Changes in battery parts

Q6BAT, Q8BAT, Q8BAT-SET

FA-A-0242-A

3.1 Q6BAT

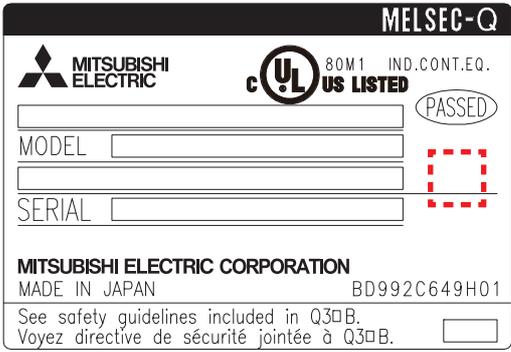
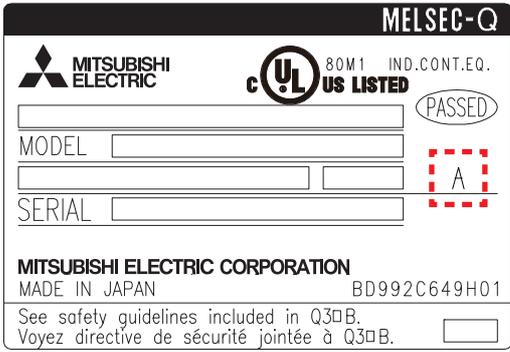
For the Q6BAT, the battery after change can be distinguished by the model name of the unit cell on the label.

Item	Before change	After change
Model	CR1733SE-R	CR2/3 8-L
Location on the label
